Service Bulletin No. 068 Rev. 1

Jasco Alternator Wire Harness Wire Chafing Protection or Replacement

This page transmits the revision of Service Bulletin 068 Rev. New to Service Bulletin 068 Rev. 1, dated August 28, 2017.

Figure 1 - Wire Harness Chafing Condition

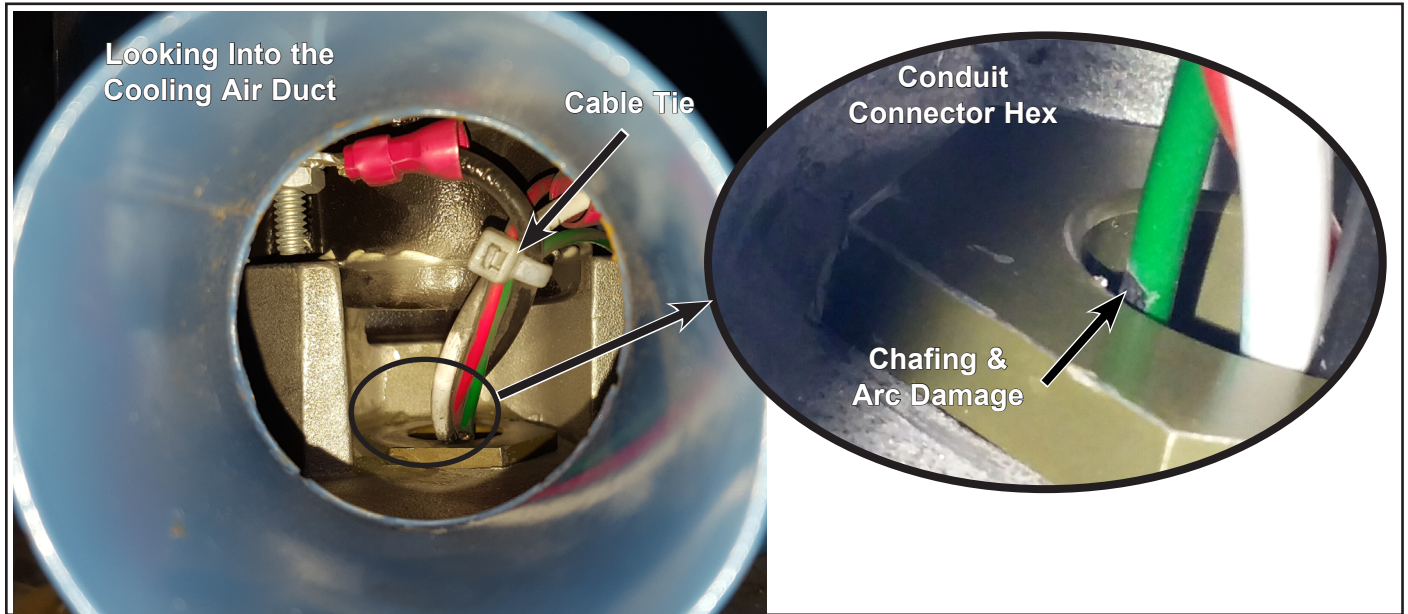
- (1) Jasco alternator models with serial numbers per the Effectivity above may experience a chafing condition of the electrical harness during normal operation.
- (2) A chafing condition of the electrical harness may result in electrical arcing, tripped circuit breaker, and loss of alternator function. Refer to Fig. 1.
- (3) Regulatory action is unknown.

- (10) Wrap the spiral insulation over the four wires using a screw action, inserting it until the spiral insulation seats against the cable tie and passes the area of the conduit connector where chafing may occur.

- (a) Tighten the spiral insulation wrap to limit any gaps. Refer to Fig. 1 and Fig. 3.
- (11) Push the knurl collar with retained grommet along the wire harness to the conduit connector.

- (i) Torque the HET P/N 41070 screws to 25-35 in-lbs (2.83-3.95 nm).
- (19) Install a cable tie to secure the wire harness at the base of the conduit connector shown in Fig. 1.

Figure 2 - Component Identification

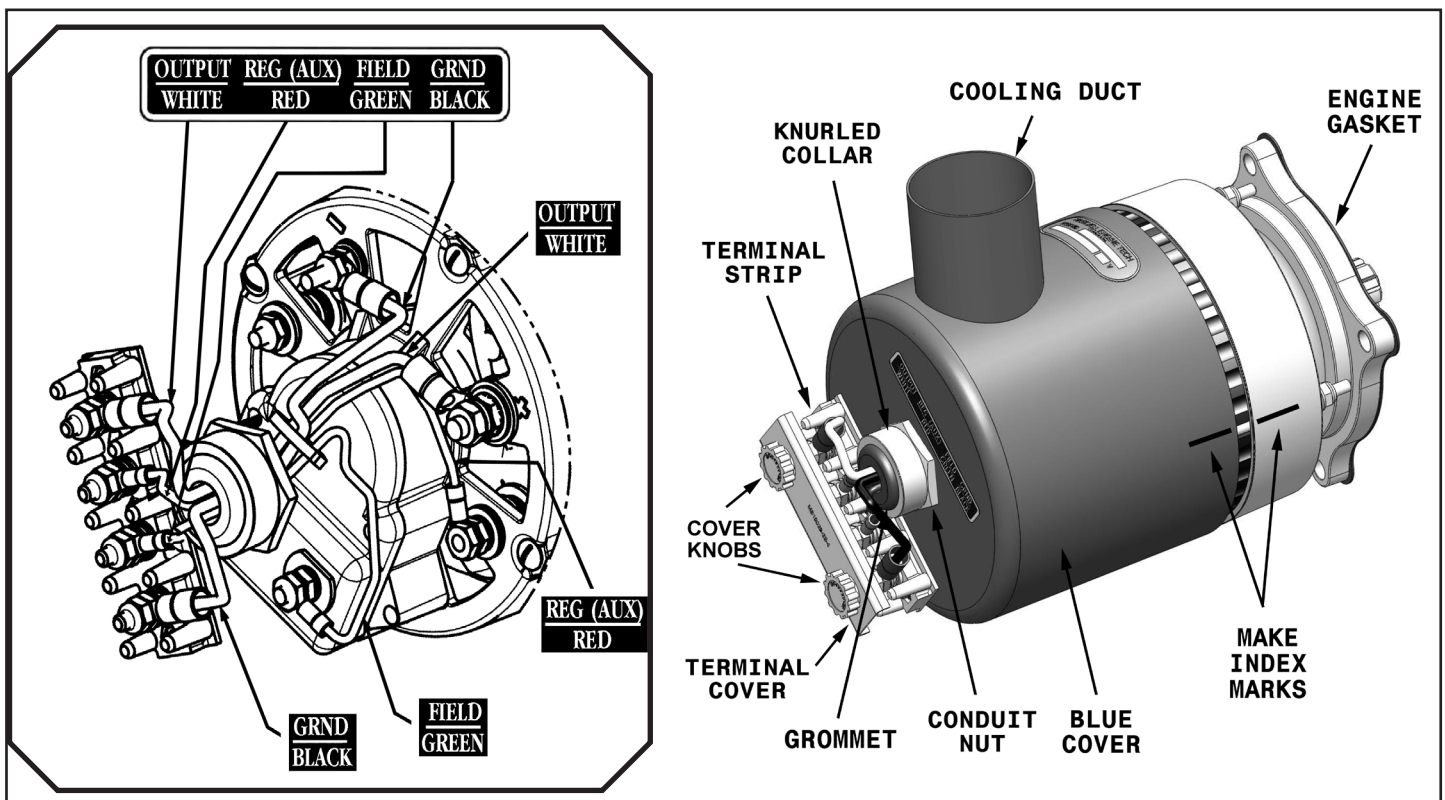
- (1) The addition of chafing protection may be performed with the alternator mounted to the engine.
- (2) Disconnect aircraft battery and other sources of electrical power.
- (3) Loosen the terminal strip protective cover knobs and remove the cover. Refer to Fig. 2.

- (8) Using a soft jaw connector plier, loosen the knurl collar completely. Refer to Fig. 4.
- (9) Move the knurl collar with retained grommet away from the conduit connector down the wire harness to allow room to install the chafing protection. Refer to Fig. 2 and Fig. 3.

- (12) Thread the knurl collar onto the conduit connector.
 - (a) Tighten the knurl collar finger tight then 1/4 turn more. Refer to Fig. 4.
- (13) Install each wire on the terminal strip stud that corresponds to the color of the wire and the color listed on the placard above the terminal strip. Refer to Fig. 2.

- (a) Put the retained flat washer and jam nut on the terminal strip stud.
 - (b) Torque each AN315-3R jam nut to 30-40 in-lbs (3.39-4.52 nm).
- (14) Install each AIRCRAFT wire on the terminal strip stud that corresponds to the function of the wire as marked and as listed on the placard above the terminal strip. Refer to Fig. 2.

- (1) The electrical harness wire replacement may be performed with the alternator mounted to the engine if sufficient space is available. If not, remove the alternator for this procedure.
- (2) Disconnect aircraft battery and other sources of electrical power.
- (3) Loosen the terminal strip protective cover knobs and remove the cover. Refer to Fig. 2.
- (4) Remove and discard the four nylon insert lock nuts from the terminal strip wire studs.
- (5) Remove the four AIRCRAFT wires from the stud.
 - (a) Insulate and tag each wire function.
- (6) Remove and retain the four 10-24 jam nuts and washers from the terminal strip wire studs.
- (7) Remove the four color coded wires from the terminal studs and pull them straight.
- (8) Put an index mark on the blue cover extending onto the drive end housing. Refer to Fig. 2.

- (9) Using a soft jaw connector plier, loosen the knurl collar completely. Refer to Fig. 4.
- (10) Pull and remove the knurl collar with retained grommet from the conduit connector. This allows removal of the blue alternator cover to expose the other end of the wire harness. Refer to Fig. 2.

- (13) Remove the blue alternator cover to expose the wire harness connections. Refer to Fig. 2.
 - (a) Cut the small cable tie that secures the wire harness. Refer to Fig. 2.

- (20) With the new wire harness extending through the conduit connector, put the blue cover onto the alternator assembly and align it with the index mark applied in step 3.C(8). Refer to Fig. 2.

Figure 3 - Spiral Insulation Example

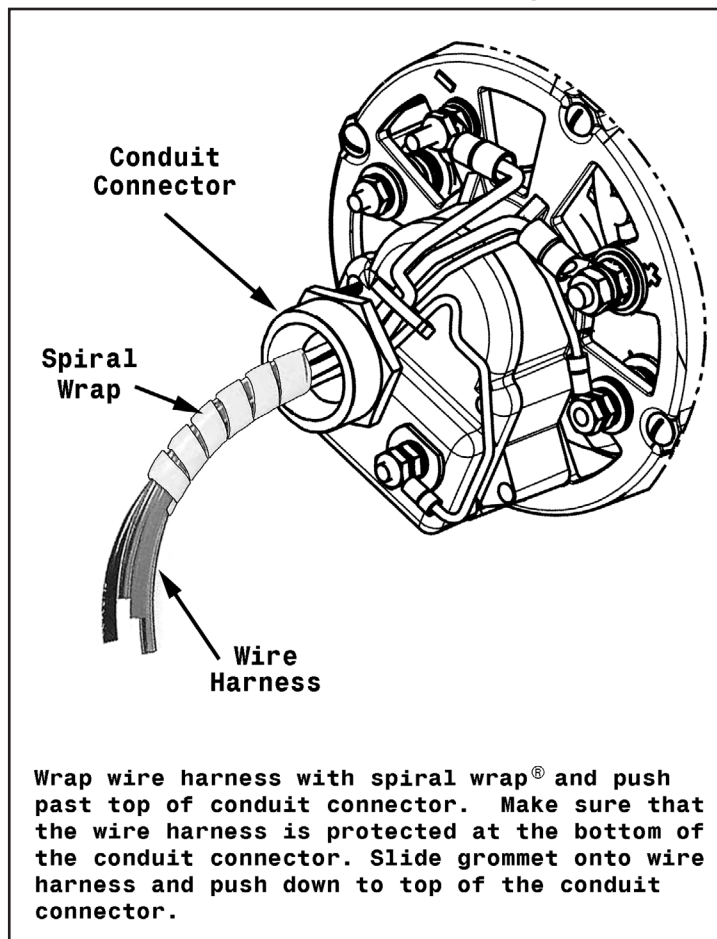
- (a) The chafing protection is a two inch piece of .375 inch PTFE spiral insulation that must be wrapped around all four wires of the wire harness. Refer to Fig. 3.

Figure 5 - Machine Support Removal

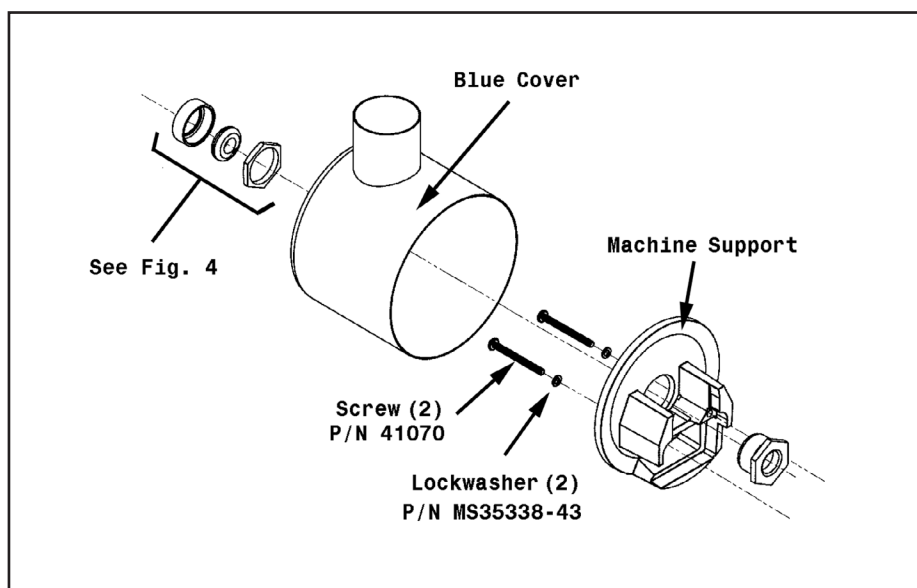
- (a) Thread the green AUX wire through the conduit connector and connect it to the stud.
 - (b) If torque of the green AUX wire nut cannot be achieved, it is permissible to remove the machine support by removing the two HET P/N 41070 screws and lockwashers. Refer to Fig. 5.

- (c) Torque the #10-24 inch jam nut to 30-40 in-lbs (3.39-4.52 nm).
 - (d) If removed, reinstall the machine support using the existing screws with new lockwashers P/N MS35338-43.
